Strategic Solution Gate One Submission:
Query Responses

Anglian to Affinity Transfer

August 2021

Figure 3 with updated dates to reflect the detail above is provided below:

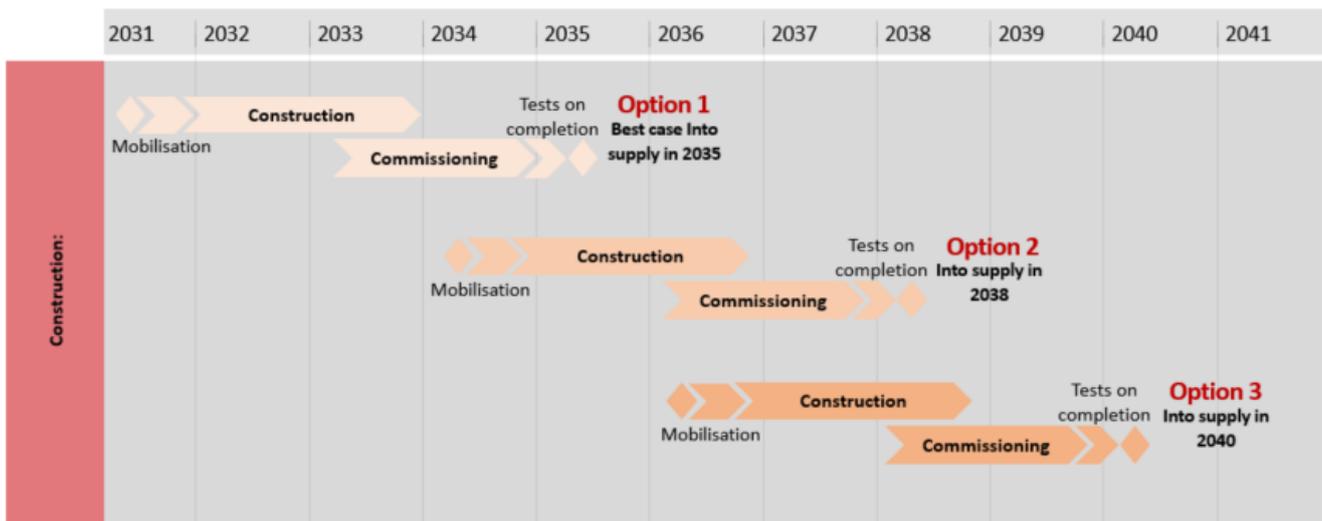
In section 3.2 you state that the earliest deployable output date is 2029 and this is illustrated in figure 3 and shows mobilisation to start in 2025. However, this conflicts with your assumption that the scheme will be delivered by DPC and planning permission will be achieved through a DCO route and figure 2 shows that the DCO application will only be submitted in 2025 and the Outline Business Case will be submitted towards the end of 2025. Please confirm your assumptions underpinning your estimated earliest possible deployable output date.

The mobilisation date of 2025 for option 1 of the indicative construction timescales within Figure 3, and referred to in section 3.2, are a theoretical timeline that is presented independently of any associated supply side scheme to provide an indication of how long the A2AT scheme might take if it were considered in isolation.

Referring to Section 3.3 assumptions and dependencies, assuming the A2AT is selected within the WRE regional plan and that either the South Lincolnshire Reservoir (SLR) or Fens Reservoir are selected as the source of water, the earliest deployable output for the transfer will align with the respective construction

programmes of the SLR and Fens Reservoir. Both of these schemes currently estimate an earliest deployable output date of 2035.

As indicated in Figure 3, the A2AT construction programme has been initially estimated at four years. As such, in order for the A2AT construction programme to be integrated with the likely deployable output dates for the SLR and Fens Reservoir, indicative dates for construction mobilisation for A2AT would be 2031, 2034 and 2036, for options 1, 2 and 3, respectively.
